**DEVIATION REVIEW  
 AND DECISION FORM**

Subdivision or Project Name: Saddlehorn Ranch Preliminary Plan

# SADDLEHORN RANCH REDUCED RADIUS VARIANCE REQUEST

SADDLEHORN RANCH  
REDUCED RADIUS VARIANCE REQUEST  
25142.00  
08/19/19  
SHEET 1 OF 1

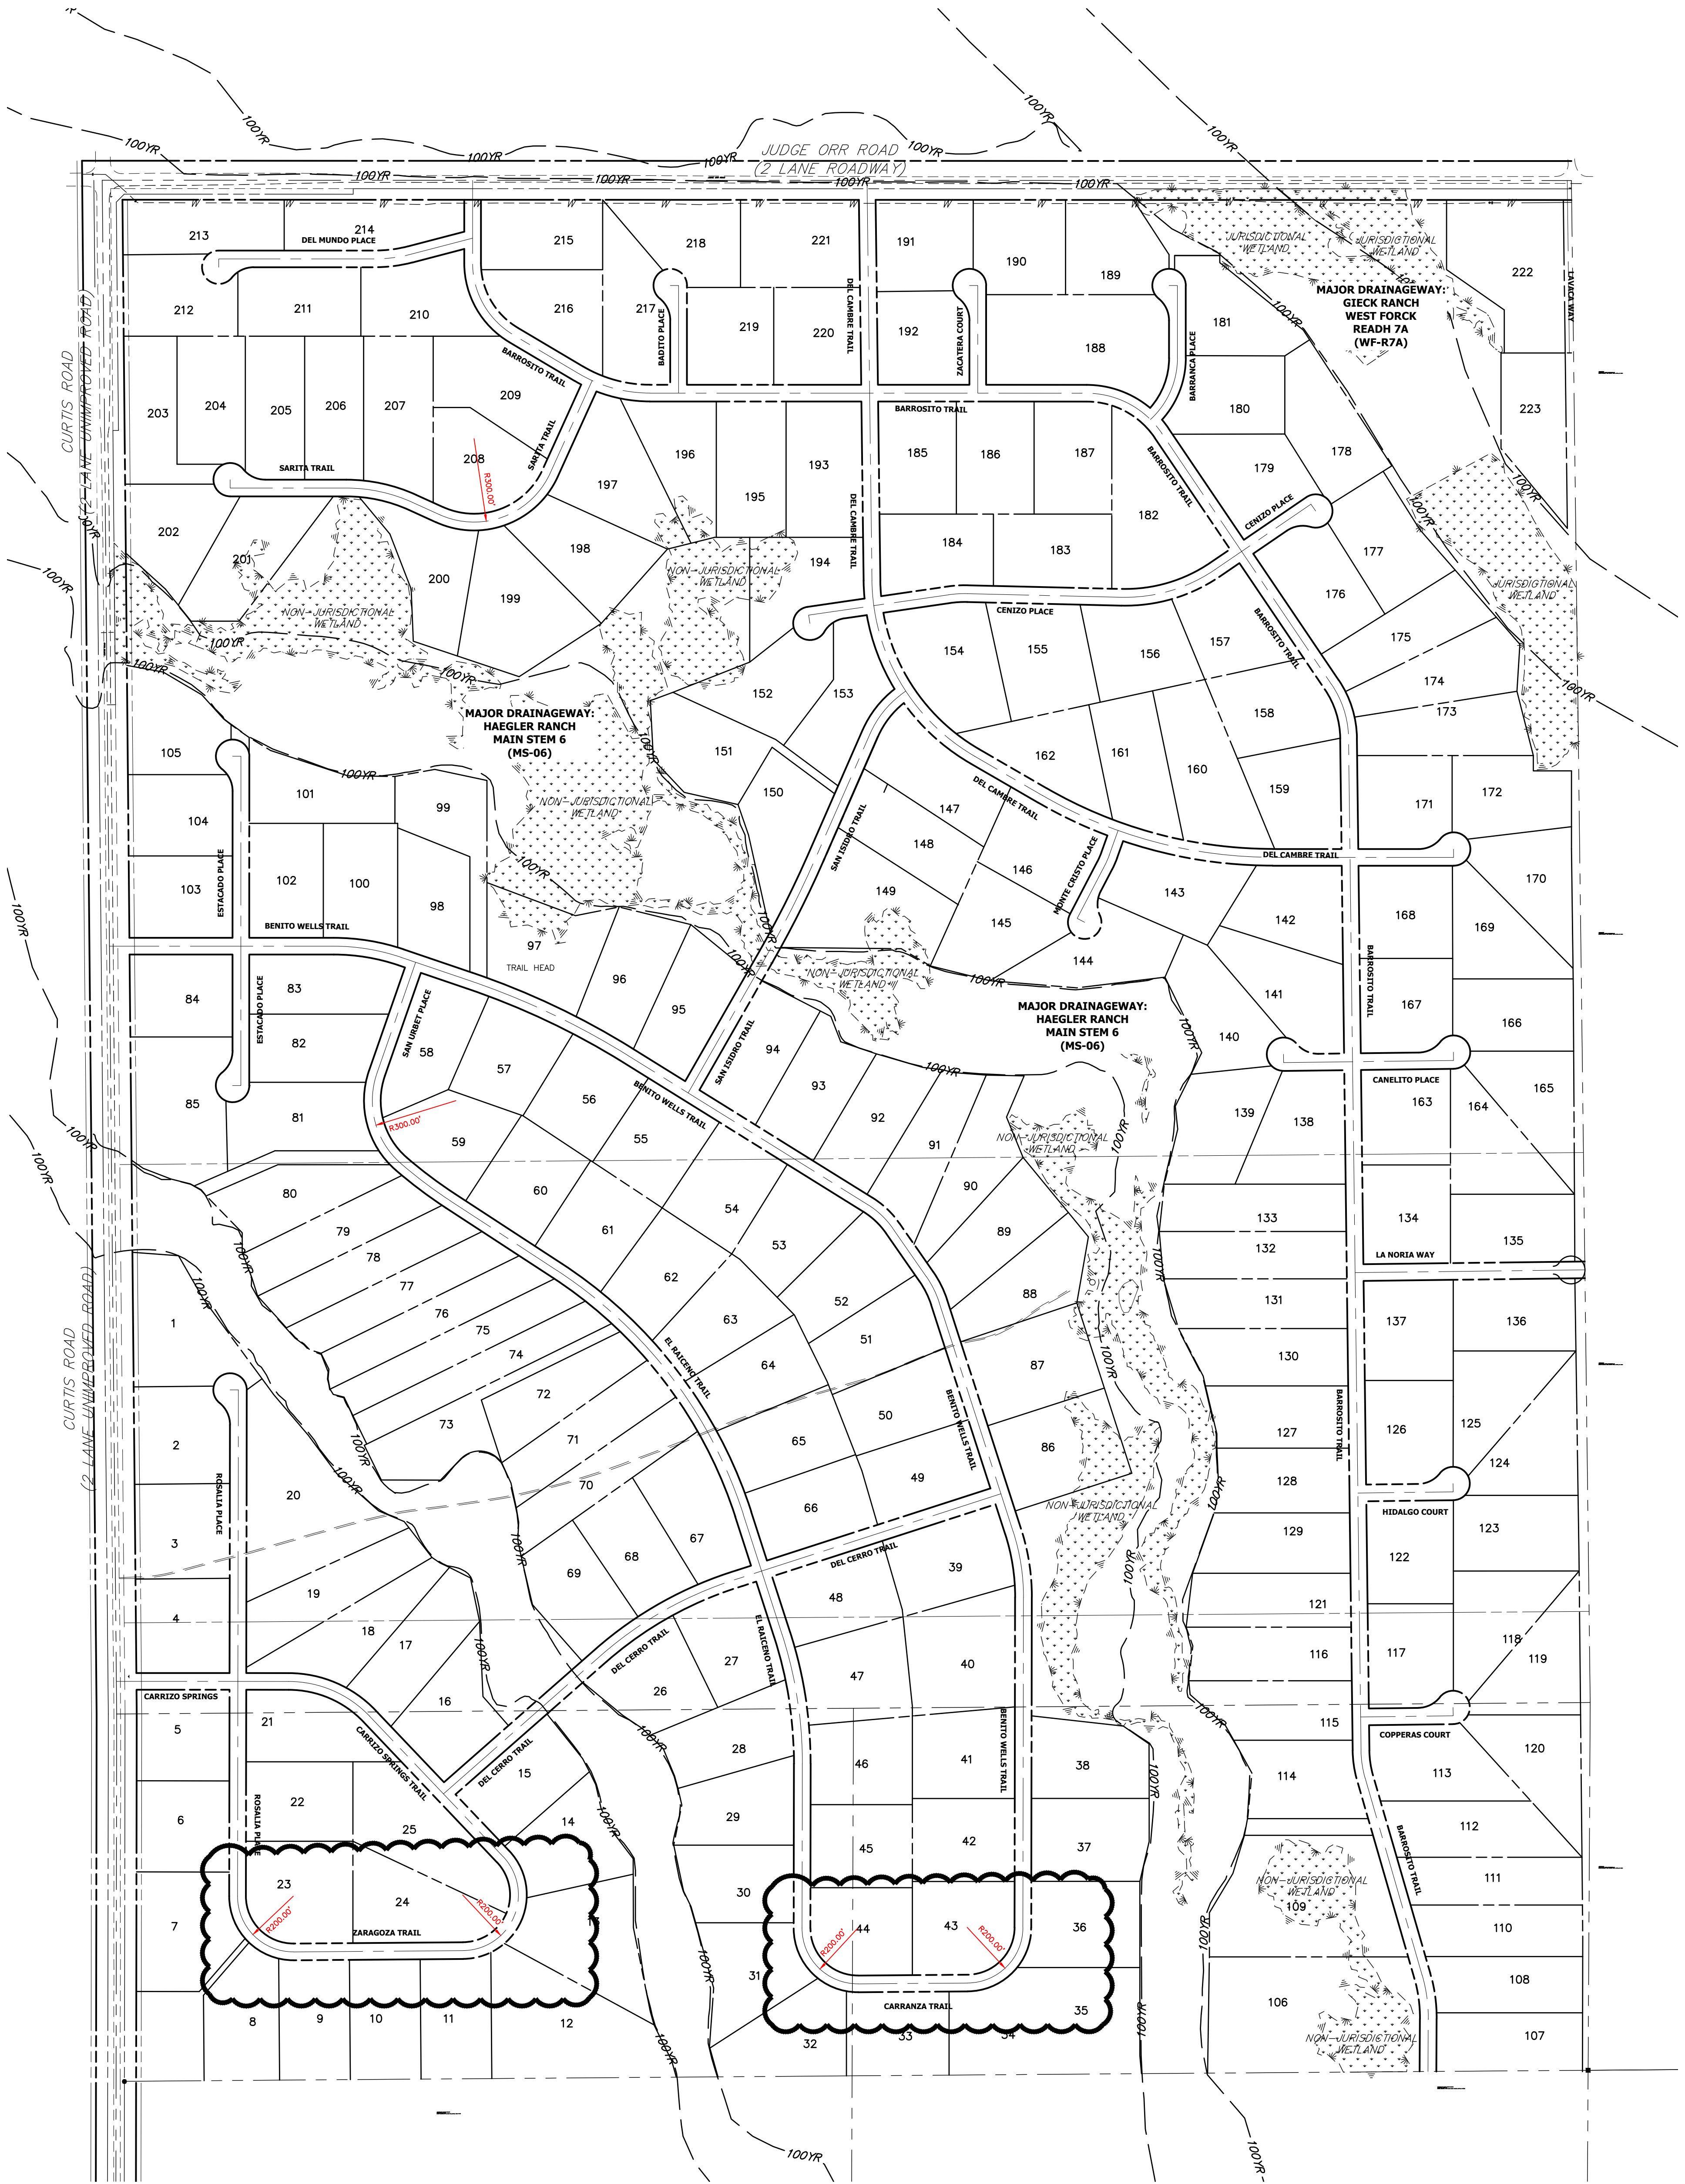
Proposed Nature and Extent of Deviation: Applicant wishes to use a 200 ft. radius at four locations shown on Attachment 1.

Proposed Nature and Extent of Deviation: Applicant wishes to use the urban local centerline radius in 4 locations within the property as opposed to the rural local centerline radius of 300 ft.  
See Attachment 2 for ECM criteria for rural local centerline radius  
See Attachment 3 for ECM criteria for urban local centerline radius for comparison

In the four locations where the deviation is requested, the natural features of the site (floodplain constraints and nearby Curtis Road).lends itself to the use of a "reduced radius" to create an efficient layout. Each area serves less than ten lots. Use of the required 300 ft. centerline radius would create the need for either excessively long flag lots or excessively large lots for the underlying R2.5 zoning

Use of standard radius curves would create excessively large lots in these specific areas or create the need for excessively long flag lots or create excessively large lots. If deviation granted applicant would reduce the posted speed from 30 mph (rural local) to 25 mph (urban local). The daily traffic volume on these streets is minimal, each location only serves 10 or less nearby lots.
